City of Edina: 54th Street Reconstruction and Arden Park Area Stormwater Plan

Design Scenario Stakeholder Feedback

30 September-10 October 2013

West, Scenario 2: Highlights and Unique Features

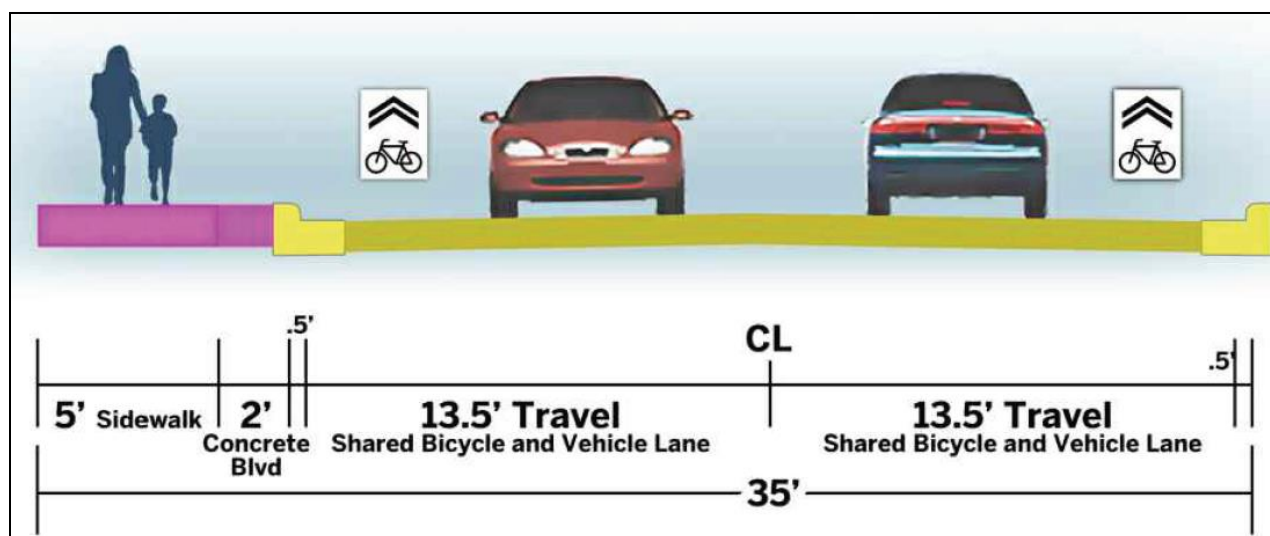
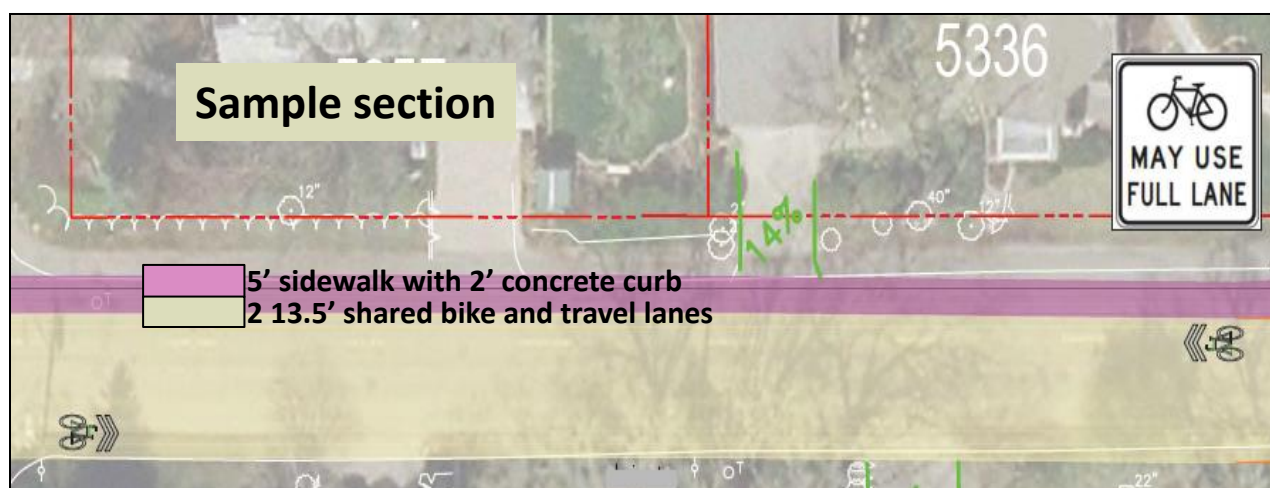
- Don't want to widen road, remove trees, or put in more impervious surfaces
- Dedicated bike lanes are dangerous because they are often filled with debris or road hazards and bikers avoid the lanes

- This is a narrow WOL.
- All the expansion is to the north. It's better to bury the power lines and balance the width increase between the north and south side. Also, narrow the travel lane to 12 to 13 feet - This way key objectives can be met with no change to the total width of the street.

- Get rid of 2 foot curb,
- only need 1 foot curbs, no rumble strip , drawing is not centered
- Still 1' wider than necessary; 34' CENTERED along the 60' right-of-way can work along 54th from Wooddale to bridge

- Tree removal.
- loss of side yard space only on the north side of street
- improvement is not centered on the street right of way
- The plans show the "eroded" areas like that is a lot line. A 7' sidewalk is completely unnecessary! We

- Do these replace utility pole lights?
- Is the road centered
- Why not center-split the loss between North and South?
- Can sidewalk go to south side? Church, school bus stops, bridge, businesses, etc.

- Why remove the trees?
- Why do we need a 2' concrete curb? Why 13.5 ft. travel lanes vs. 11 ft.? Other streets with shared bike lanes have 11 ft.
- Have lanes, curbs, sidewalk designed into current width. Remove bike share.

- Where can I see the map for 54th and Oaklawn? If you can remove garages, why can't the utility boxes on 5401 Oaklawn property be buried?
- Who pays for the tree removal? How does tree removal adhere to the Living Streets Policy?
